SERVICE BULLETIN

No. 362

Piper Aircraft Corporation

V_{ne} Airspeed Limit

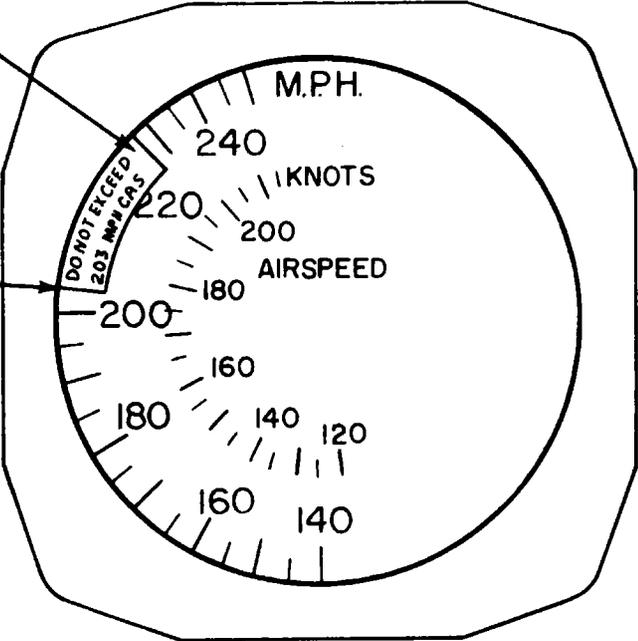
Install Placard SK-2285 on the face of the Airspeed Indicator as shown.

Locate this edge of Placard at 203 M.P.H.
